Project	IEEE 802.16 Broadband Wireless Access Working Group < http://ieee802.org/16 >	
Title	Clarify downlink burst profile change management	
Date Submitted	2005-01-19	
Source(s)	Chi-Chen Lee Tzu-Ming Lin Yu-Ren Yang Industrial Technology Research Institute, Computer and Communications Research Labs, Taiwan Bldg. 11, 195 Sec. 4, Chung Hsing Rd. Chutung, HsinChu, Taiwan 310, R.O.C.	Voice: 886-3-5914579 Fax: 886-3-5829733 mailto: jjlee@itri.org.tw mailto: TMLin@itri.org.tw mailto: yryang@itri.org.tw
Re:	IEEE P802.16-REVd/D5	
Abstract	This contribution introduces clarifications for DL burst profile change management procedures.	
Purpose	Adopt into P802.16d/D5 corrigenda	
Notice	This document has been prepared to assist IEEE 802.16. It is offered as a basis for discussion and is not binding on the contributing individual(s) or organization(s). The material in this document is subject to change in form and content after further study. The contributor(s) reserve(s) the right to add, amend or withdraw material contained herein.

Clarify downlink burst profile change management

6.3.10.1 Downlink burst profile management

Figure 79—Transition to a more robust burst profile

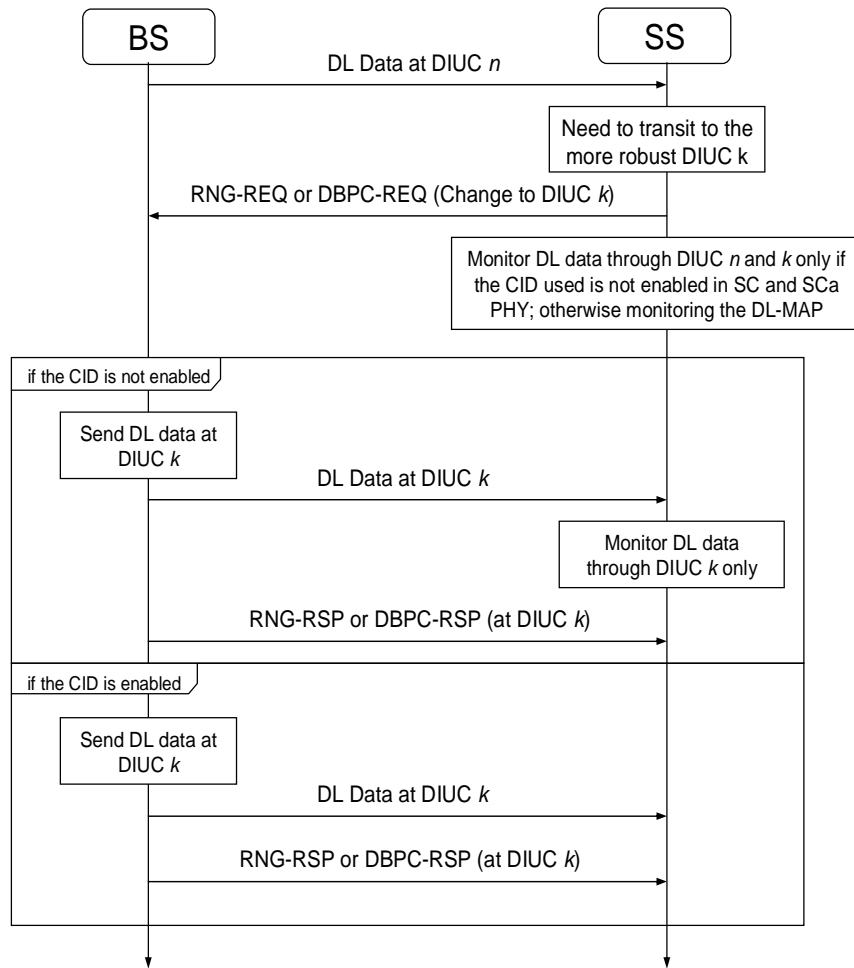
In IEEE P802.16-REVd/D5 “Figure 79 —Transition to a more robust burst profile” and “Figure 80—Transition to a less robust burst profile”, the SS must monitor DL data through two different DIUC while changing the DL burst profile. This scenario is reasonable only if the *CID used* is **not** enabled by burst profile for SC and SCa PHY (see Table 139 and Table 190). In the case of OFDM, OFDMA PHY and in the case of SC, SCa PHY that the *CID used* is enabled by burst profile, the SS’s basic CID is included in each DL-MAP_IE. Thus, the SS can check the DL-MAP for its basic CID and know what DIUC it should use. This design improves the energy efficiency of the SSs that have power consumption constraints. Due to the lack of consistency between this design and the procedures defined in specification, we provide two modified figures to clarify this issue.

[Replace Figure 79 and Figure 80 with the following figures.]

Figure 81a—Wait for response during change of DL burst profile—SS

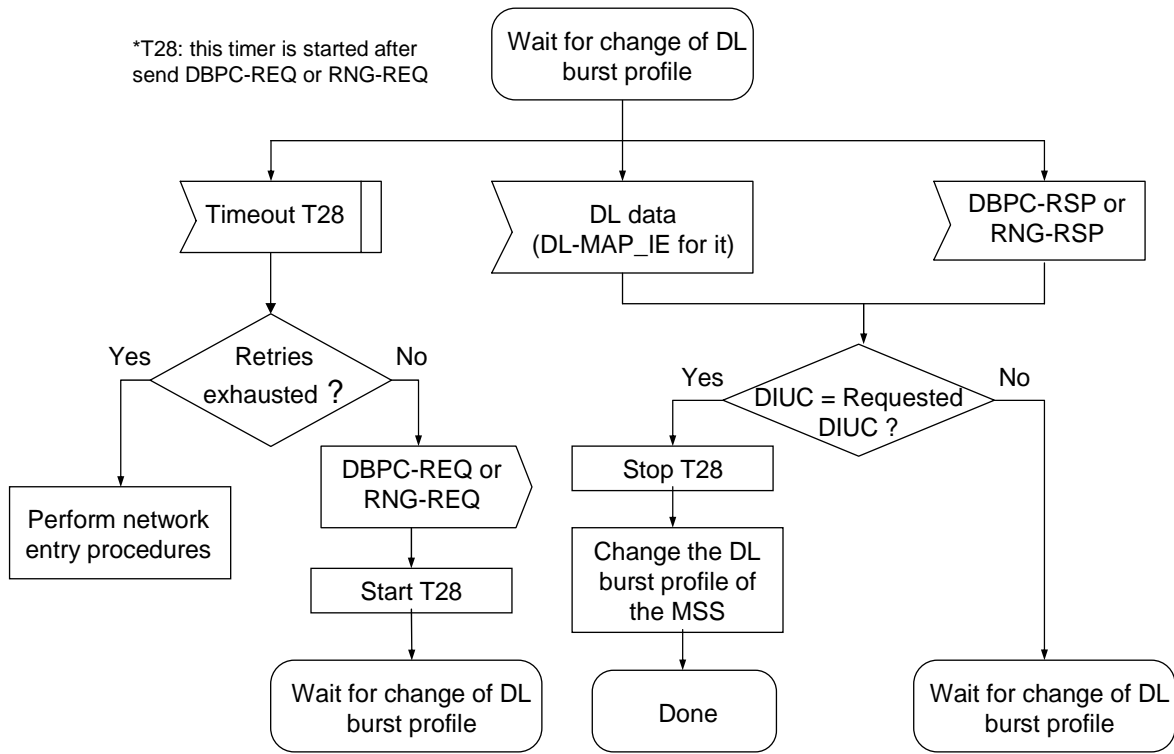
We notice that DL burst profile management does not mention how the SS deals with the loss of the change request. However, the change request may be lost due to contention or harsh mobile environment. Therefore, the additional flow chart (see Figure 81a) is proposed to make the change of DL burst profile more robust. The new timer T28 is designed for handling the loss of the DBPC-REQ or RNG-REQ during the change of DL burst profile. Note that the BS should send DL data at new DIUC or send the DBPC-RSP or RNG-RSP to the MSS before T28 times out.

[Insert new figure before “Figure 81 – Burst profile threshold usage” with the following figure.]
